UNITED STATES PATENT AND TRADEMARK OFFICE

Office Action Summary

10/539,160

GRADEL ET AL.

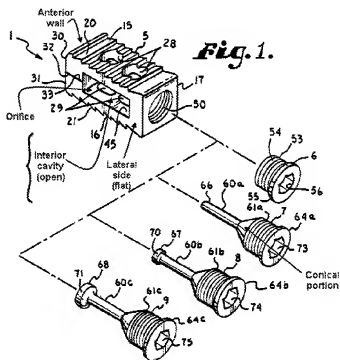
Jackson discloses an intervertebral implant (1) comprising a solid biocompatible material implant body (5) having a tubular general structure delimited by an upper wall (15) and a lower wall (16), two opposite lateral walls (see Figure 1 below) that are plane and slightly divergent toward the front, and a posterior wall (17) with a threaded axial hole (50), with a single interior cavity (see Figure 1 below; paragraph 0036) providing communication between orifices provided in the upper wall (15) and the lower wall (16), wherein: the upper (15) and lower (16) wall each comprise a respective single large upper or lower orifice (45, 46), an interchangeable compression plug (6, 7, 8, 9; paragraph 0034); the interior cavity is closed toward the front by an anterior wall (see Figure 1 below), the width of the implant (1) defined by the lateral walls is less than its

height defined by the upper and lower wall. It is noted that Jackson's implant could also be cylindrical in shape (paragraph 0011), therefore allowing the width of the implant to be less than its height. Because of the upper and lower orifice, the interior cavity is open over the whole of its width between the lateral walls and over the whole of its length between the posterior and anterior wall (see Figure 1 below).

The interchangeable compression plug (6, 7, 8, 9) comprises a conical interior end portion (see Figure 1 below). The interchangeable compression plug (6, 7, 8, 9) and the threaded axial hole (50) that receives it have a diameter substantially equal to the width of the interior cavity in the vicinity of the posterior wall (see Figure 1 below). The interchangeable compression plug (6, 7, 8, 9) has a length such that, at the end of screwing it into the threaded axial hole (50) that receives it, its interior end portion penetrates the interior cavity to a distance of at least one quarter of the length of said interior cavity (paragraph 0041-0043). The implant (1) has at least two interchangeable compression plugs (6, 7, 8, 9; paragraph 0034) having different lengths (paragraph 0041). The anterior wall includes an eccentric threaded hole of smaller diameter (paragraph 0038). The upper and lower larger wall include annular toothed anti-expulsion ribs (paragraph 0037). The interchangeable compression plug is made of titanium (paragraph 0011). The upper (15) and lower wall (16) are each of conical general shape and the upper and lower orifice are each bordered at their anterior and posterior ends by a flat perpendicular to the lateral walls (see Figure 1 below).
